RE: Revised (December 4, 2019) Air Quality Modeling Protocol and Monitoring Exemption Request for the Longview Power Unit 2 Project

**WV DEP Division of Air Quality**  
**Comments on Revised Air Quality Modeling Protocol and Monitoring Exemption**  
**Request for the Longview Power Unit 2 Project**  
**Submitted September 23, 2019 via electronic**  
**mail November 20, 2019**  
**Revised Final Protocol 4 December 2019**

REVISED FINAL

**Figure 2-3**  
**Plot Plan**

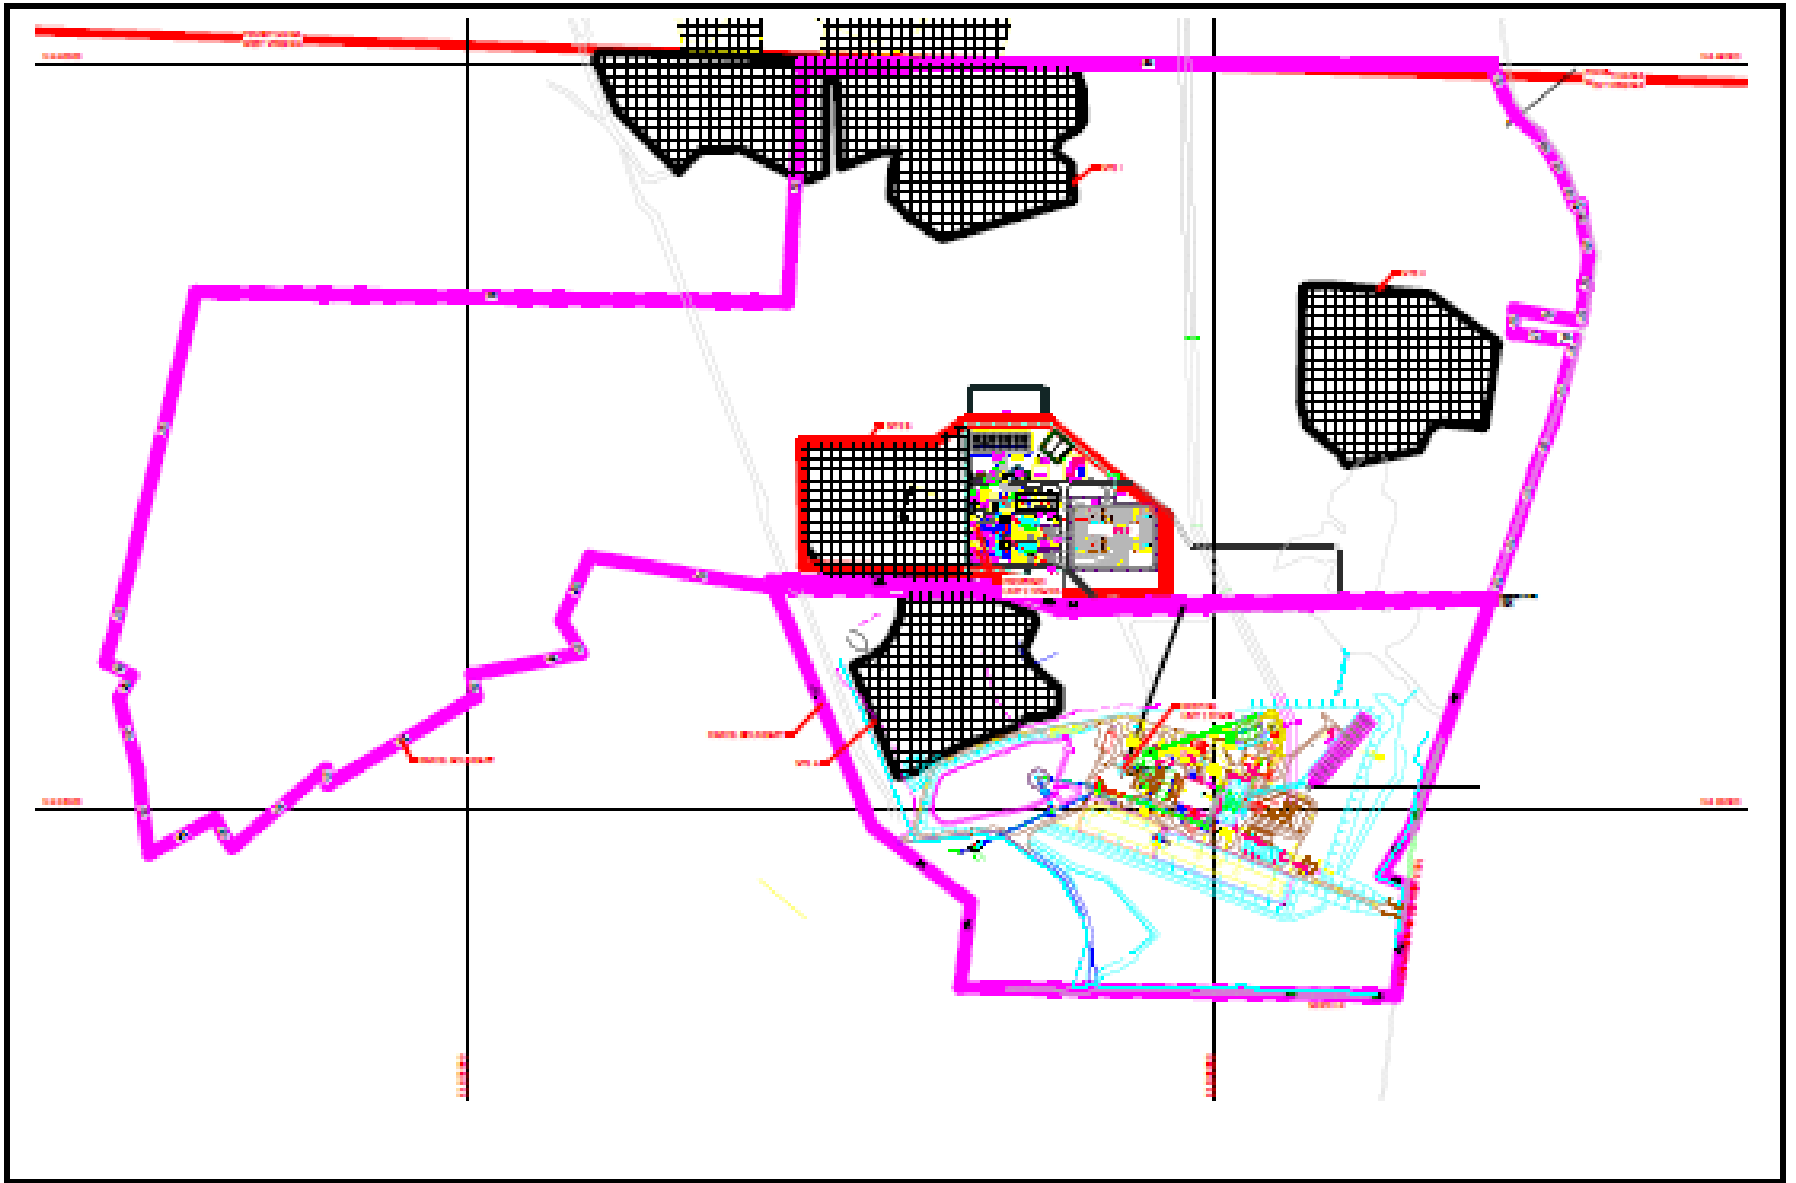
**20. Please label Figure 2-3, Plot Plan.**

Figure 2-3 has been labeled Plot Plan in the revised air quality modeling protocol.

**Figure 6-4  
Wind Rose for Morgantown Airport (2014-2018)**

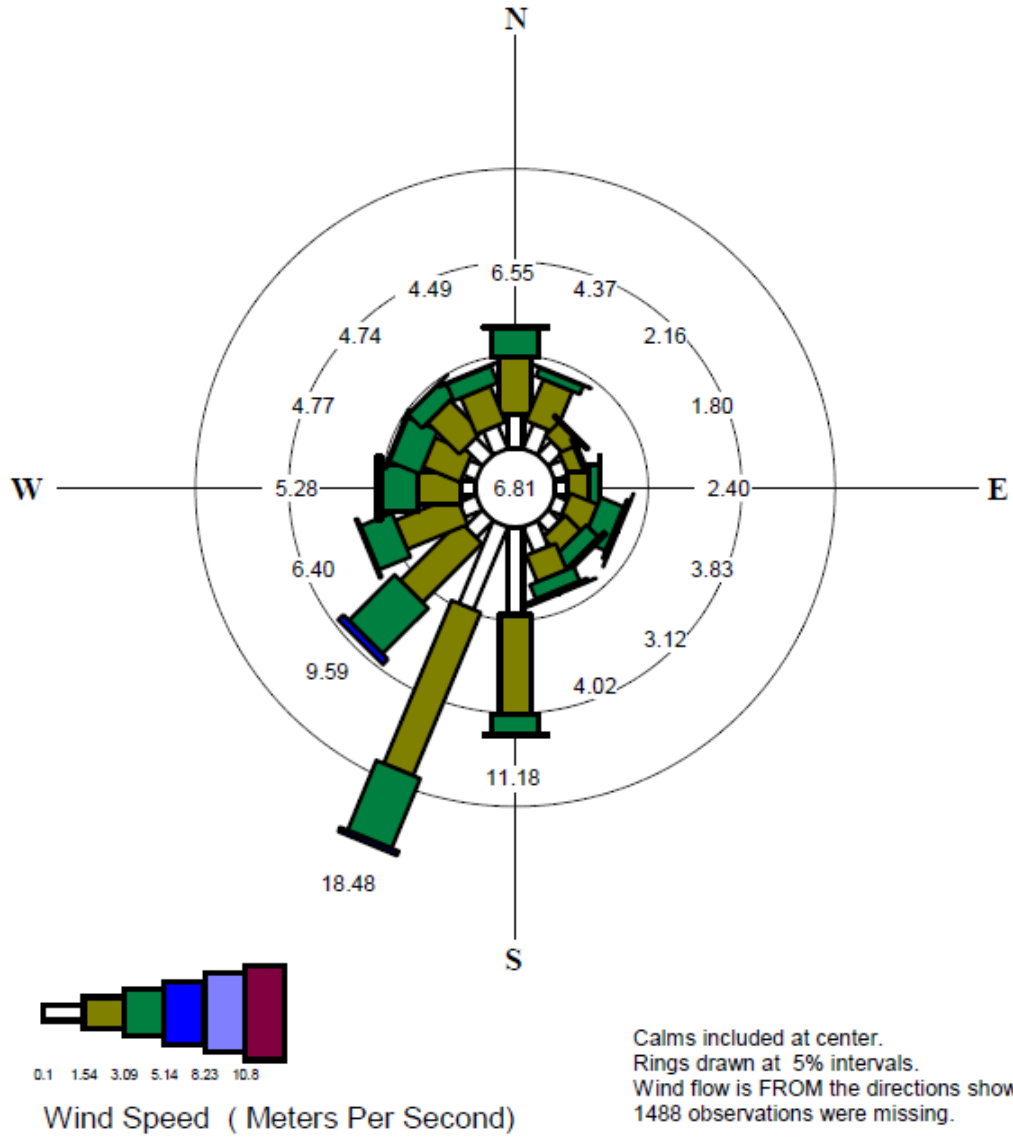
**22. Figure 4-1 notes that calms are excluded from the wind rose. The percentage of calms should be noted on the figure.**

Figure 4-1 has been revised to include the percentage of calms.

**Figure 2-3  
Plot Plan**

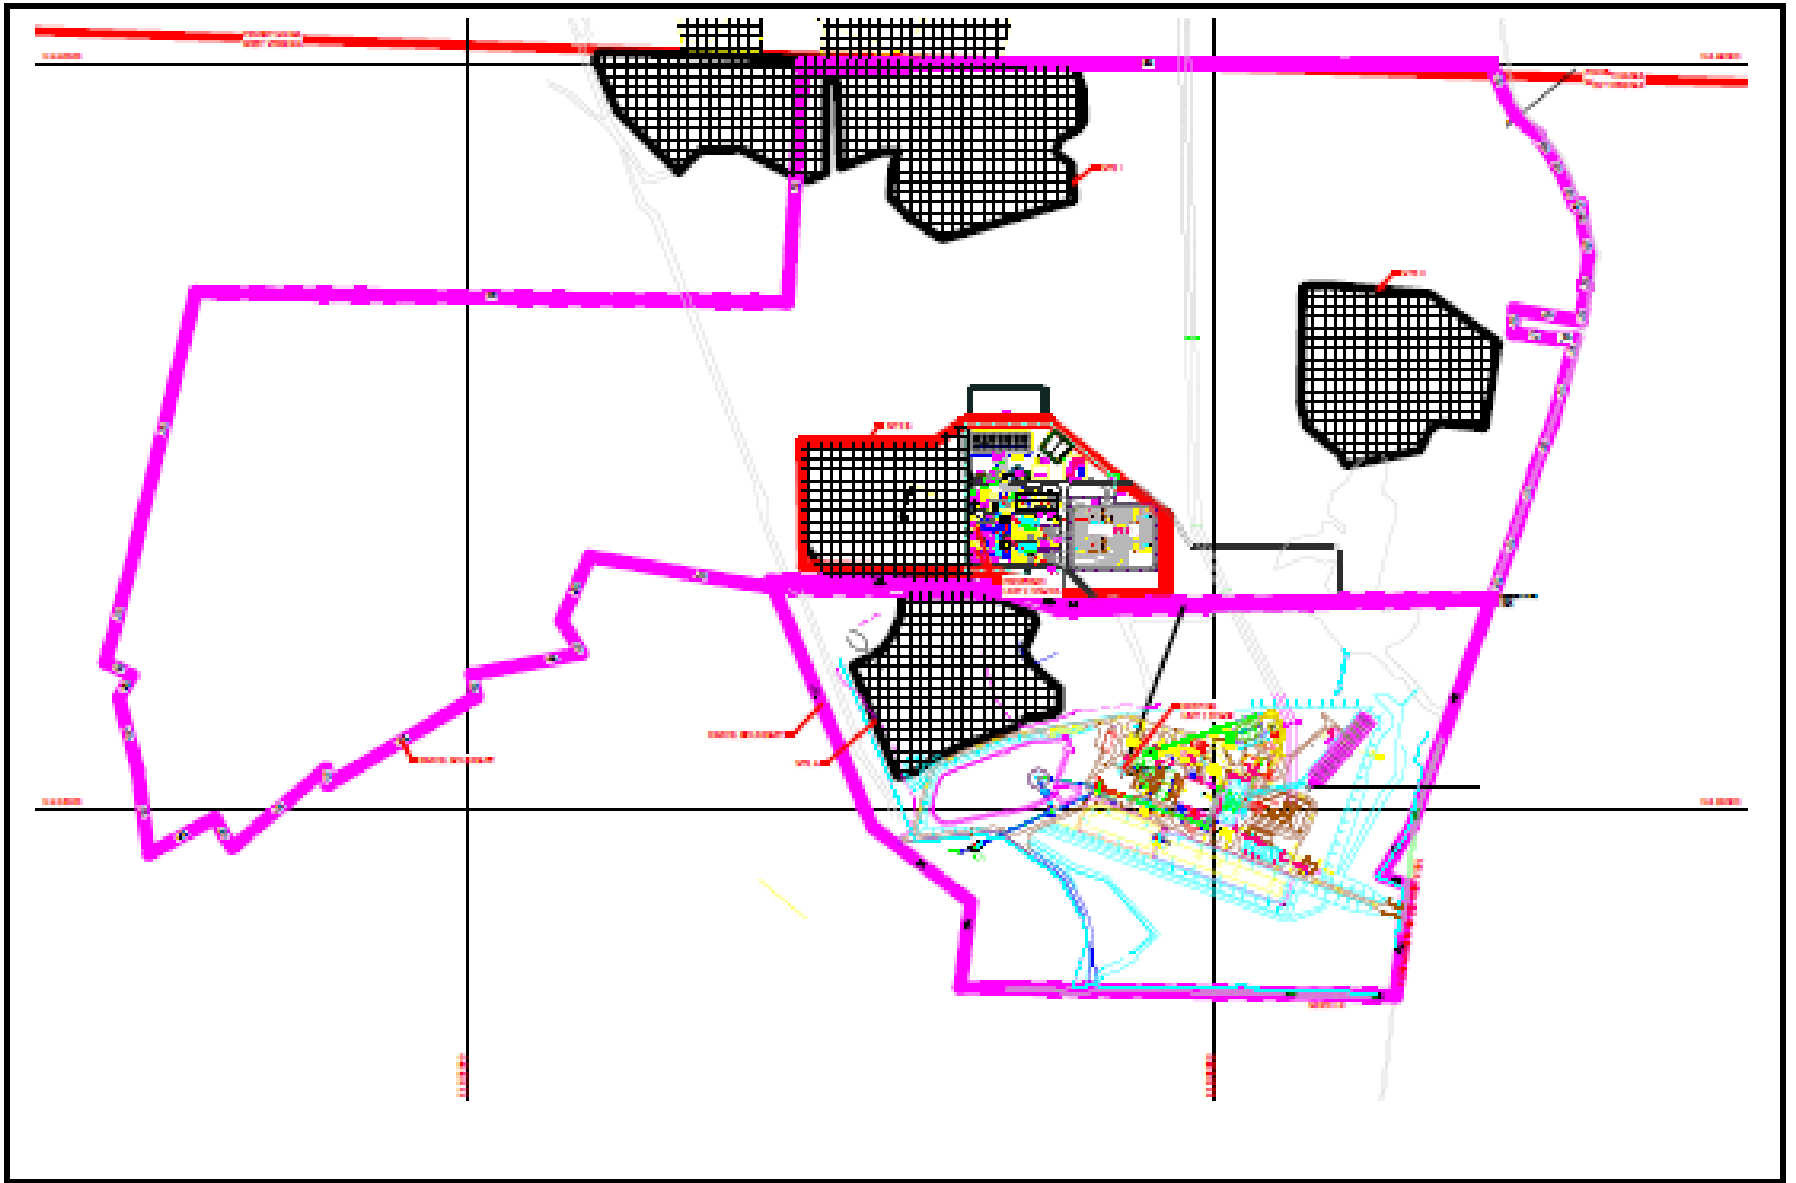
19. Please label Figure 2-3, Plot Plan.
20. The protocol proposes surface meteorological data from the Morgantown Municipal Airport from 2013 to 2017. The most recent five years of data should be used. It appears that 2018 data is available from the Morgantown Municipal Airport.

**Figure 4-1  
Wind Rose for Morgantown Airport (2013-2017)**

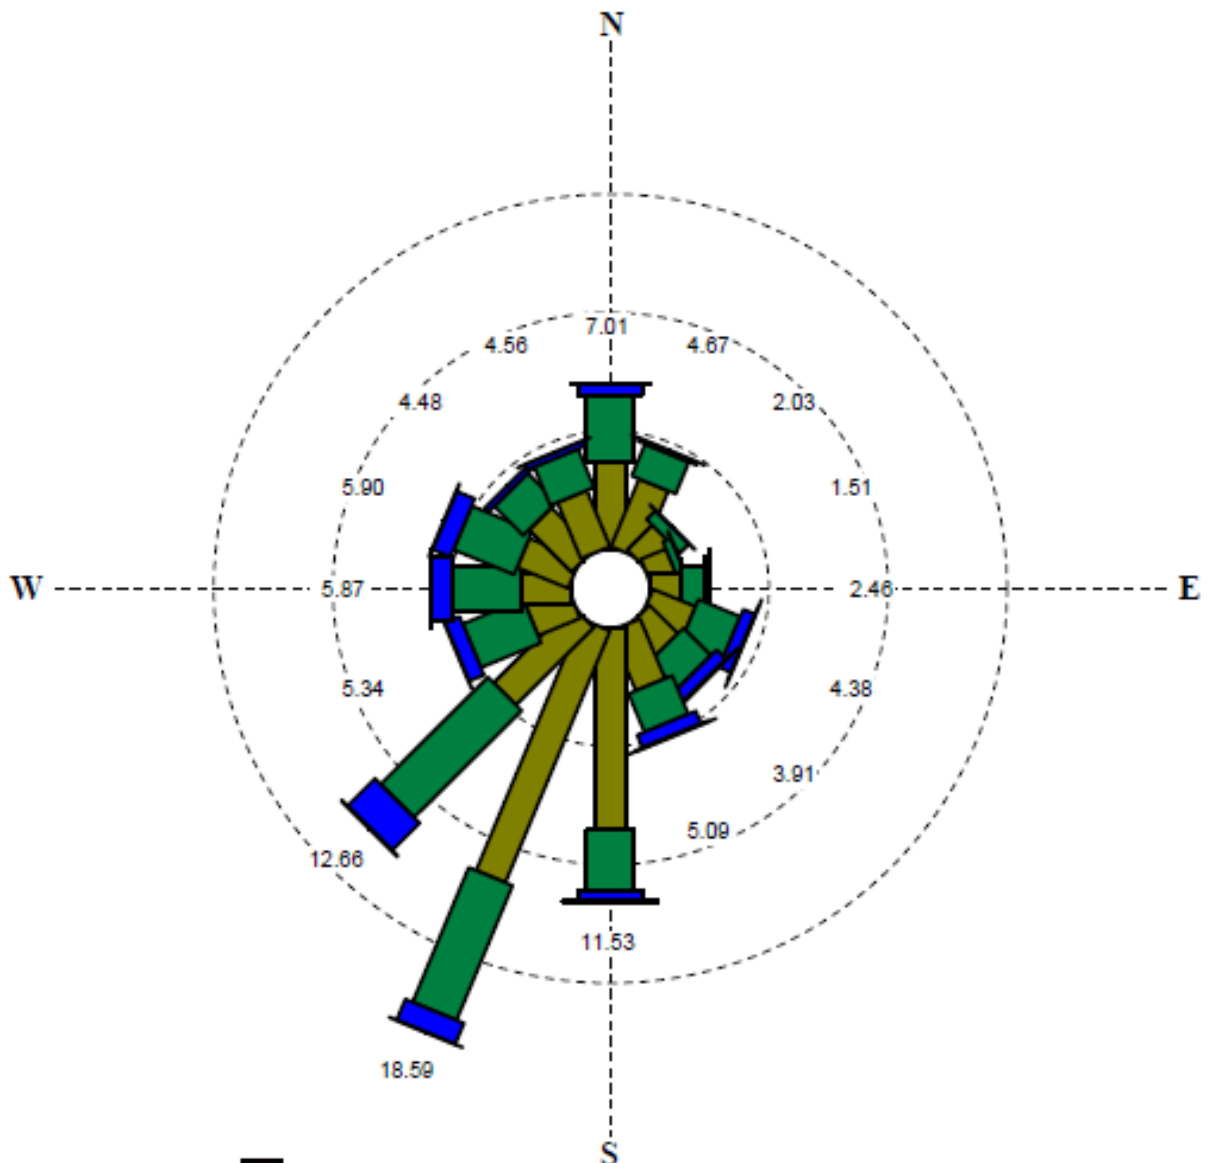
21. Figure 4-1 notes that calms are excluded from the wind rose. The percentage of calms should be noted on the figure.
